Modification Report

Westlink Industrial Estate - Stage 1 (Modification 4)

SSD-9138102

Figure 6: Comparison of approved and modified northern boundary retaining wall sections for Lot 1

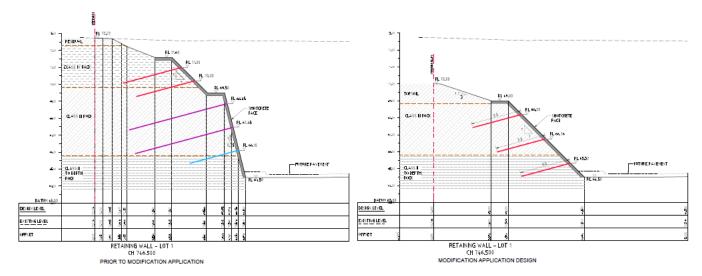
The proposed modification seeks to modify the approved development to amend the approved design of the retaining wall along the northern boundary of the estate, adjacent to Lot 1. Specifically, the height of the retaining wall along the northern boundary of the estate will be reduced and the design of the retaining wall will be amended. This modification is necessary due to a change in levels of the northern neighbouring site at 272-280 Aldington Road (Lot 15 DP 253503).

The maximum height of the approved retaining wall was RL 85.947 (20.980m) at chainage 420.00. It is proposed to reduce the maximum height of the retaining wall to RL 76.00 (11.5m), as shown in the images below, due to a change in ground levels on the adjacent neighbouring property to the north. Similarly, at chainage 280.00 in the

approved design, the height of the retaining wall was RL 72.972 (8.102m), whereas the height of the retaining wall at chainage 280.00 in the amended design is proposed to be RL 70.000 (5.5m). Overall, the retaining wall height is intended to be reduced from that as approved.
